Project	IEEE 802.16 Broadband Wireless Access Working Group < http://ieee802.org/16 >	
Title	Enhanced Idle Mode Operation	
Date Submitted	2004-05-17	
Source(s)	Hang Zhang, Mo-Han Fong, Peiying Zhu, Wen Tong Nortel Networks 3500 Carling Avenue, Ottawa Ontario, Canada K2H 8E9	mhfong@nortelnetworks.com Voice: +1-613-765-8983 Fax: +1-613-765-6717
Re:	IEEE P802.16e/D2-2004	
Abstract	Enhanced Idle Mode operation to reduce MAC signaling overhead and enable fast transition	
Purpose	Adoption of proposed changes into P802.16e	
Notice	This document has been prepared to assist IEEE 802.16. It is offered as a basis for discussion and is not binding on the contributing individual(s) or organization(s). The material in this document is subject to change in form and content after further study. The contributor(s) reserve(s) the right to add, amend or withdraw material contained herein.	
Release	The contributor grants a free, irrevocable license to the IEEE to incorporate material contained in this contribution, and any modifications thereof, in the creation of an IEEE Standards publication; to copyright in the IEEE's name any IEEE Standards publication even though it may include portions of this c

Figure XX. Location Update header format.

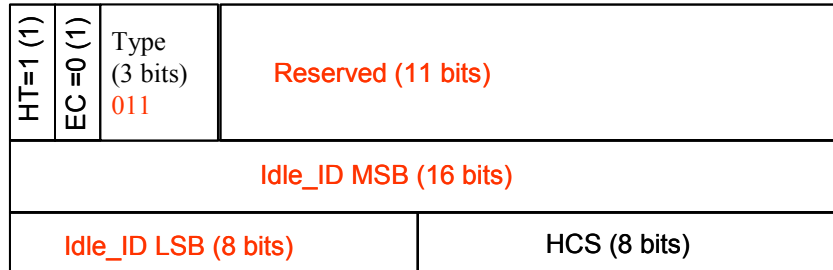
[Add Section 6.3.2.1. 4 to describe the location update (LU) MAC header format]

The location update PDU shall consist of location update (LU) header alone and shall not contain a payload. The location update header is illustrated in Figure XX.

The TYPE field shall be set as '011' to indicate that this is a location update header and no payload attached. Idle_ID field (24 bits) is the Idle_ID assigned to a MSS when the MSS enters Idle Mode.

An MSS receiving a Location Update Header on the downlink shall discard the PDU.
